NEEDHAM PLANNING BOARD Tuesday, February 2, 2021 7:15 p.m.

Re: Definitive Subdivision Application

390 Grove Street

STORMWATER REPORT & DEFINITIVE PLAN COMMENTS

REVIEW NOTES

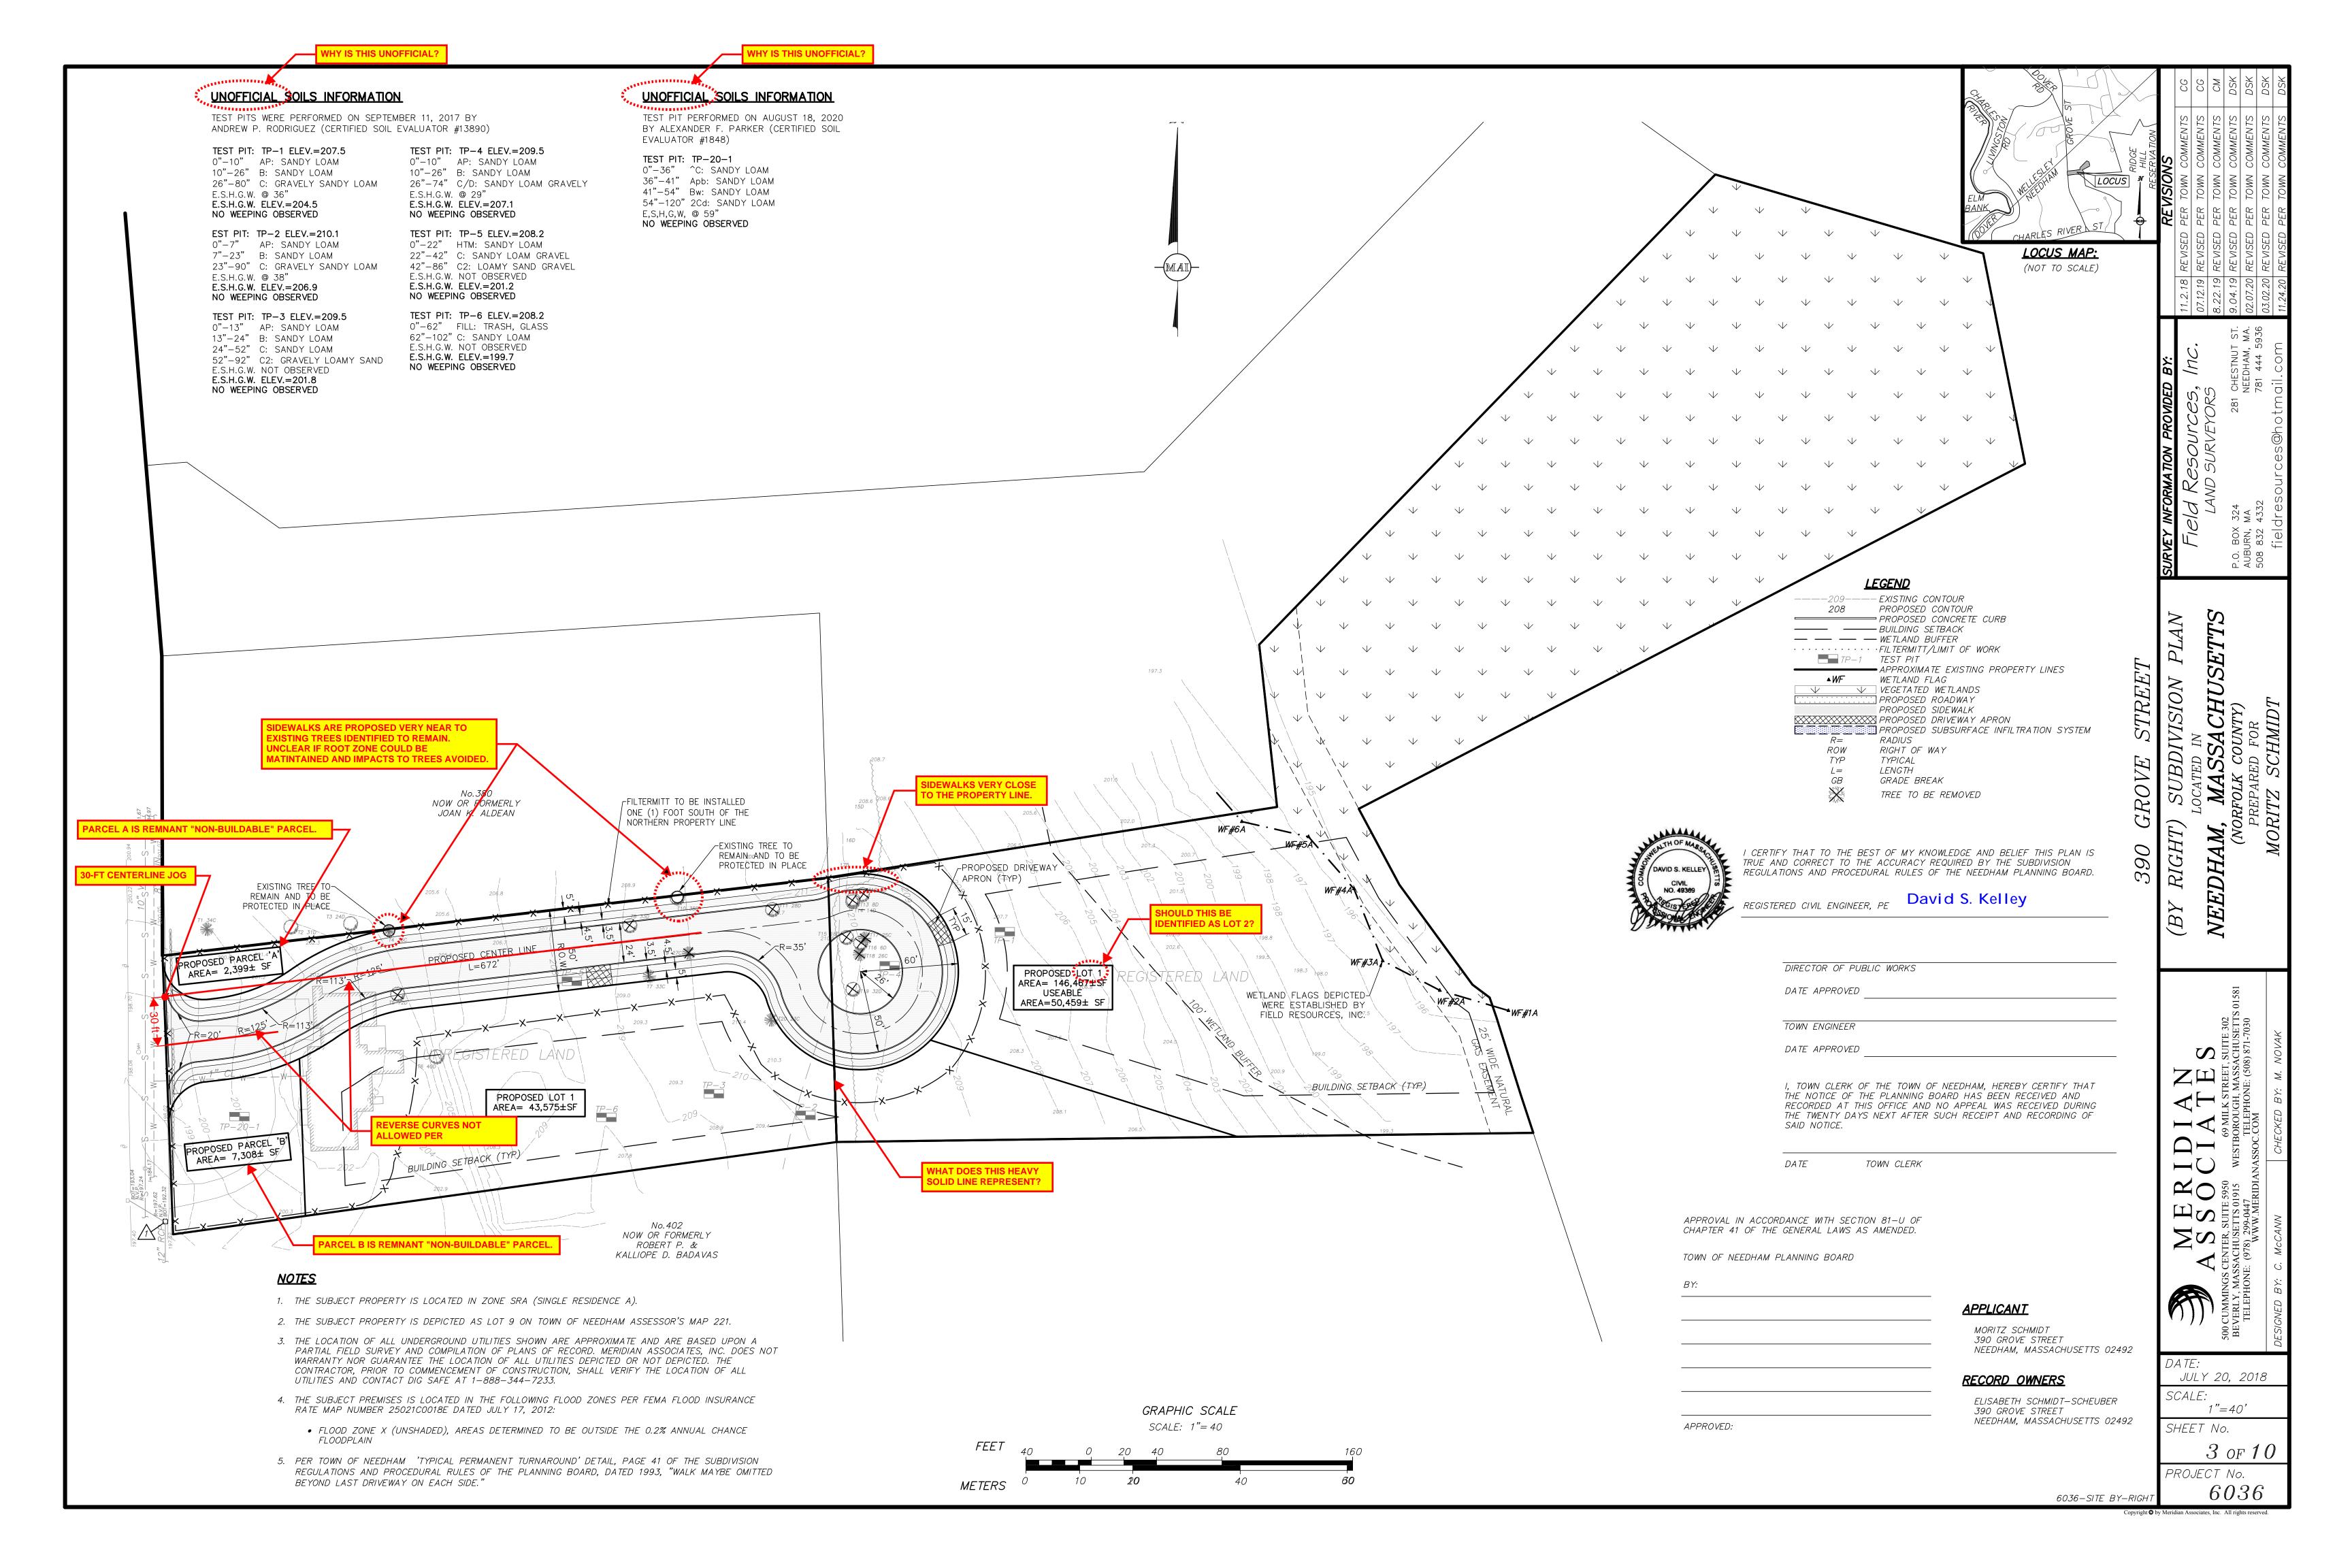
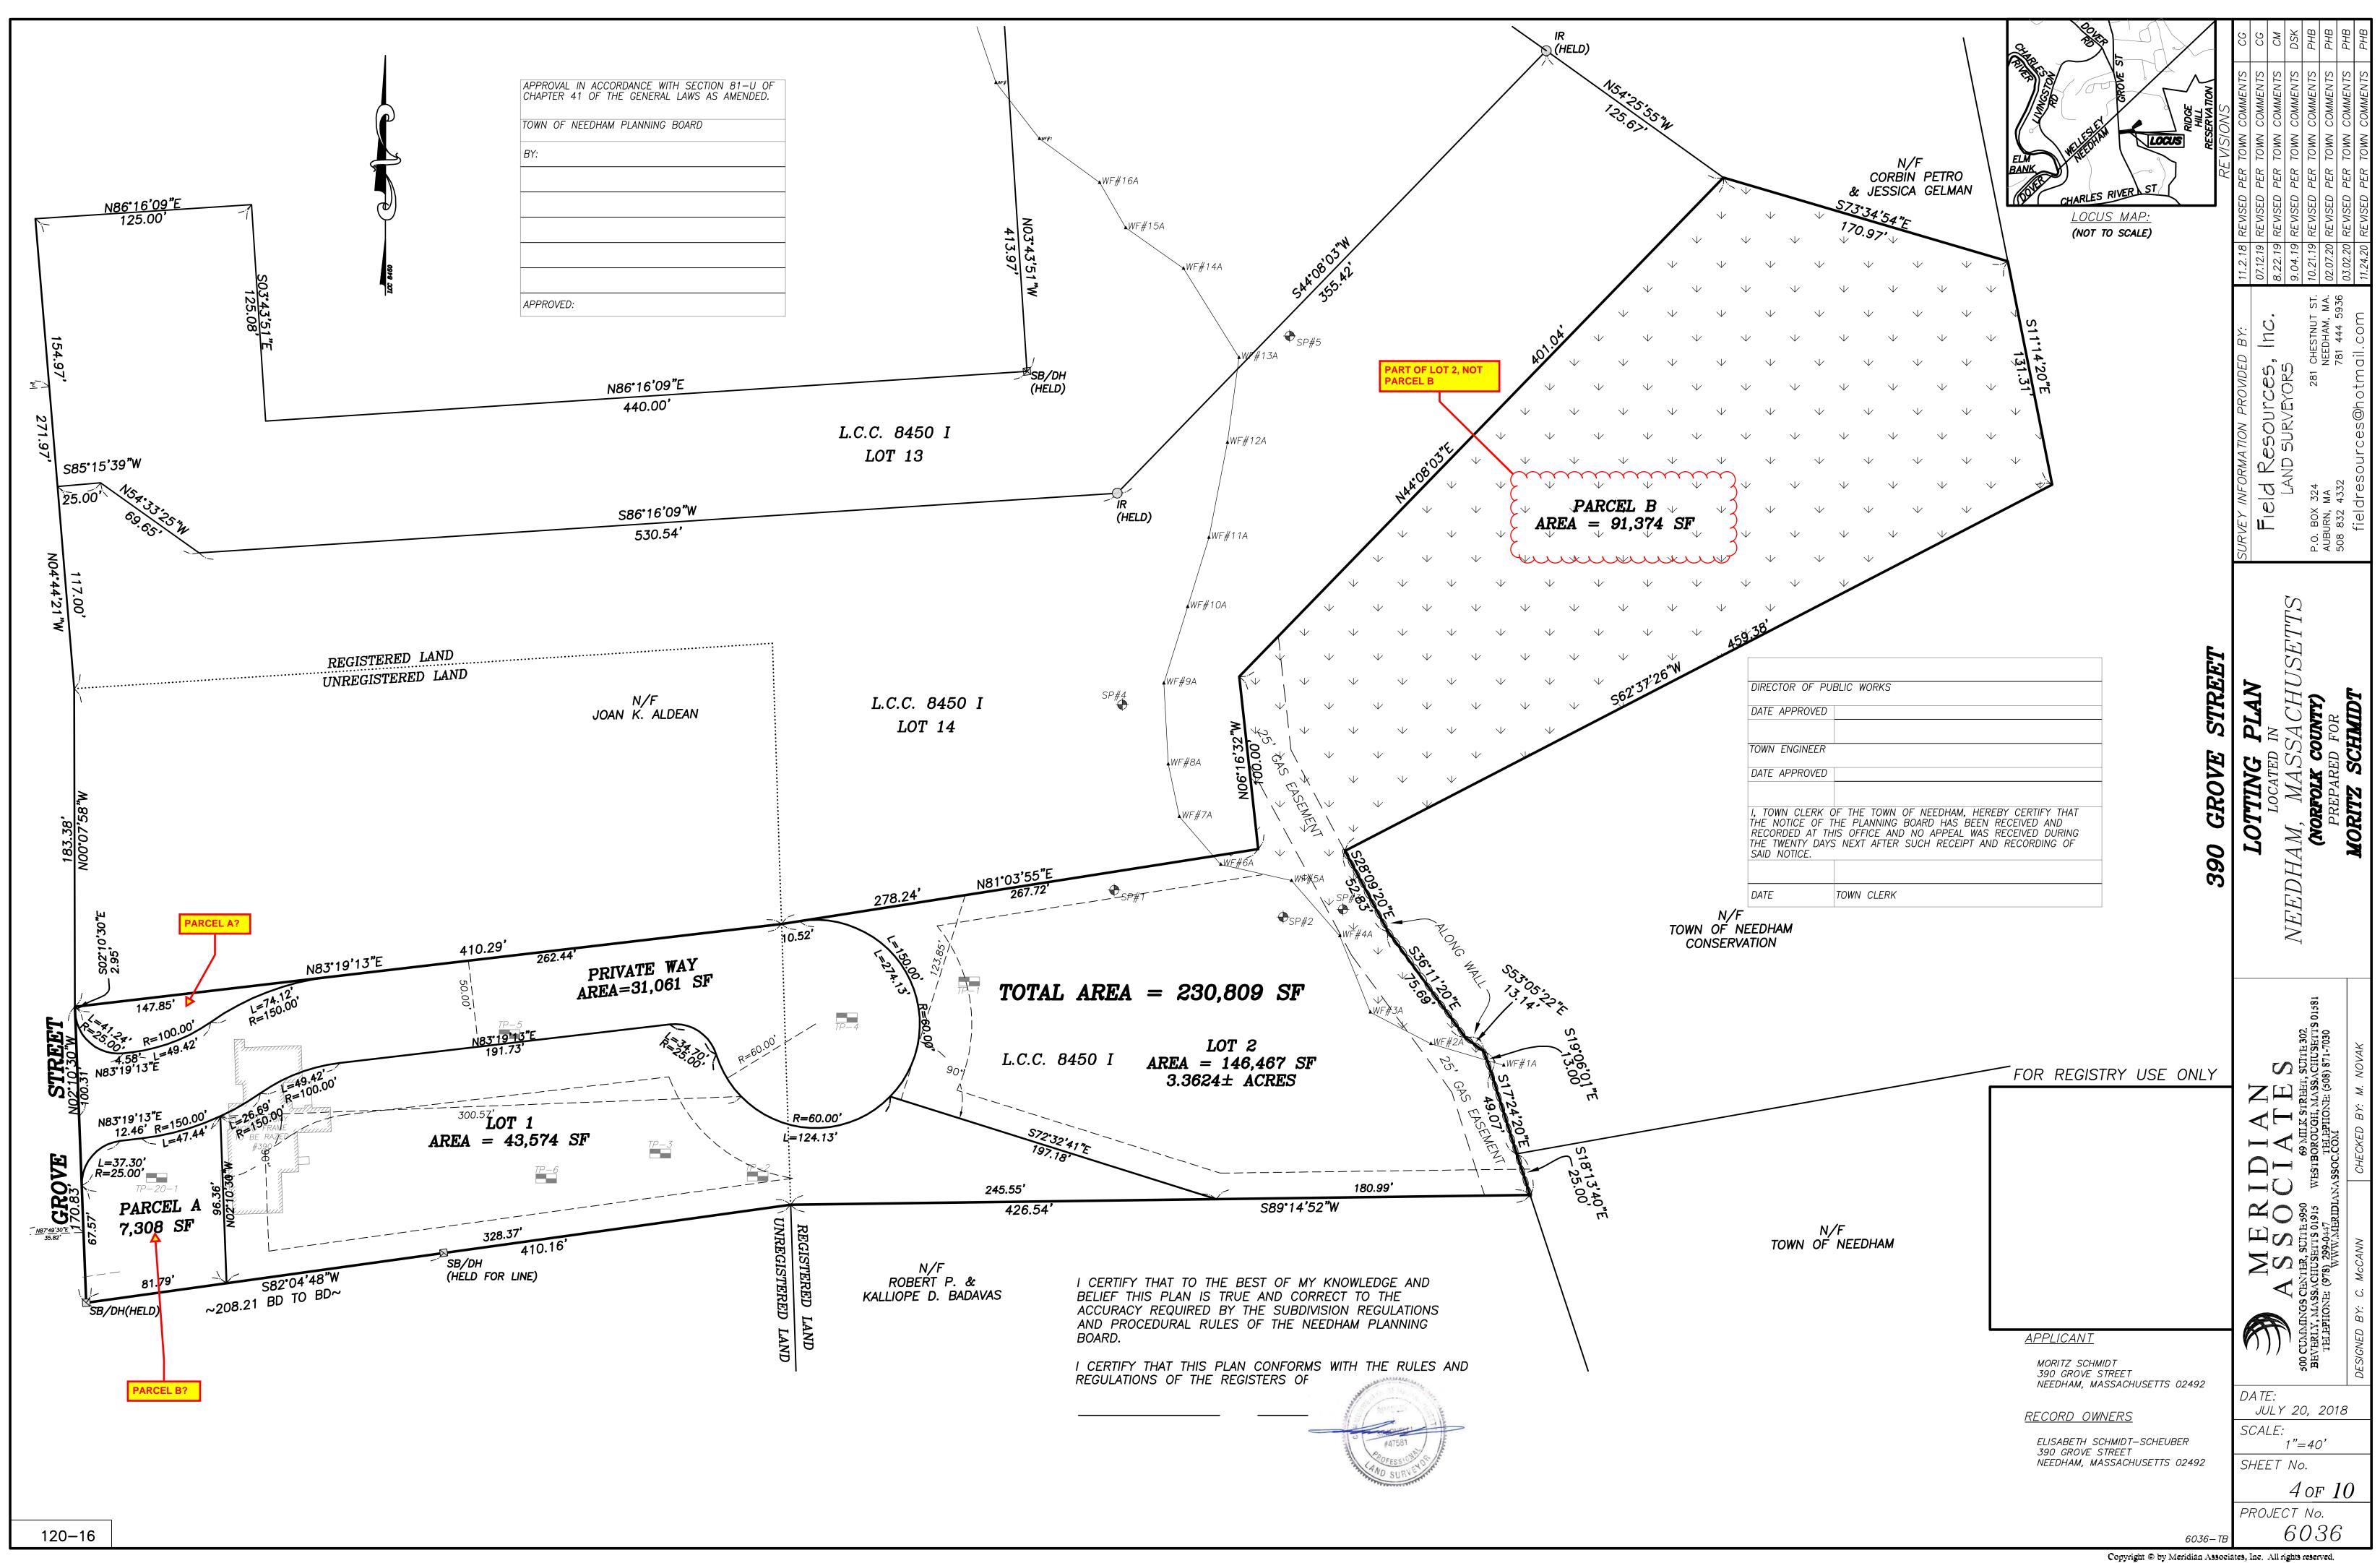
2. Per section 3.3.4 of the subdivision regulations, "Street jogs with centerline offsets of less than 125-ft, streets with varying widths and reverse curves shall be avoided." The By Right Subdivision Plan (sheet 3 of 10) and Proposed Site and Grading Plan depict a street centerline jog of approximately 30-ft at the intersection with Grove Street along with a reverse curve in order to achieve this jog both of which are in conflict with the subdivision requirements.

4. Per Section 3.3.1 of the subdivision regulations, "The grade of a street within 50-feet of a street intersection shall not exceed 1% to provide a level area for traffic safety." The Proposed Utilities & Profile Plan (Sheet 6 of 10) identifies that the road contains only a 20-foot long section of roadway that has a slope less than 1%, which is less than the 50-foot requirement.

9. The By Right Subdivision Plan (Sheet 3 of 10) does not depict proposed grading or stormwater management features that would be required for the design as depicted on the by-right plan. Additionally, the proposed sidewalks depicted on this plan are very close to the existing trees to

10. The By Right Subdivision Plan (Sheet 3 of 10) and most of the other plans identify both buildable parcels as Lot 1 and there is no Lot 2. This needs to be corrected.

11. The Lotting Plan (Sheet 4 of 10) has a number of significant inconsistencies with the remainder of the Definitive Plans. These include the following: identifying Parcel B as part of Lot 2 at the end of the proposed roadway, whereas the remainder of the Plans identify Parcel B as the remnant parcel north of the subdivision roadway parcel; identifying the remnant parcel south of the subdivision roadway as Parcel A, whereas the remainder of the Plans identify this as Parcel B; not labeling the remnant parcel north of the subdivision roadway. The Lotting Plan as presented is not complete or accurate and cannot be approved as currently presented.

15. The top of stone for Infiltration System 1 is proposed at elevation 200.3 per the details on Sheet 10 of 10. The minimum proposed finished grade above the chambers is identified to be elevation 201.33. The grading depicted on the Proposed Site & Grading Plan (Sheet 5 of 10) appears to indicate the top of chambers is slightly higher than elevation 200, but not above elevation 201 which would not provide the required amount of cover. The surface grades are proposed to slope down immediately adjacent to the proposed stormwater chambers with the surface grade less than the top of stone within approximately 5-ft of the chambers. Additionally, the bottom of chambers is proposed above the existing street grade along Grove Street. The Applicant should confirm there will not be breakout along Grove Street. The grading in the vicinity of the Infiltration System 1 and size of Parcel "B" should be reviewed to confirm this parcel has sufficient size and the drainage system is feasible as proposed.

19. The Proposed Utilities & Profile Plan (Sheet 6 of 10) shows an 8x8x6 tee connection to the existing 8" water main for the proposed 8" water main. This connection is inaccurate as it does not appear that a 6-inch pipe is proposed in this location. Additionally, the waterline appears to have less than 5-ft of cover from station 10+50 to 11+50. This should be addressed.

20. The profile included on the Proposed Utilities & Profile Plan (Sheet 6 of 10) depicts a proposed grade of 3.3% presumably along the centerline of the roadway, although the profile line appears to have a number of grade breaks at approximate stations 10+20 and 11+40. There is no information included regarding these apparent grade breaks. Furthermore, a 20-ft vertical curve is identified from station 10+00 to 10+20, although the profile appears to indicate that the centerline grade at this location is set at a uniform slope of 0.5%. These inconsistencies should be addressed.

21. The Revision Block on the Record Conditions Plan of Land (Sheet 2 of 10) is unclear and has overlapping text. This should be corrected for the record.
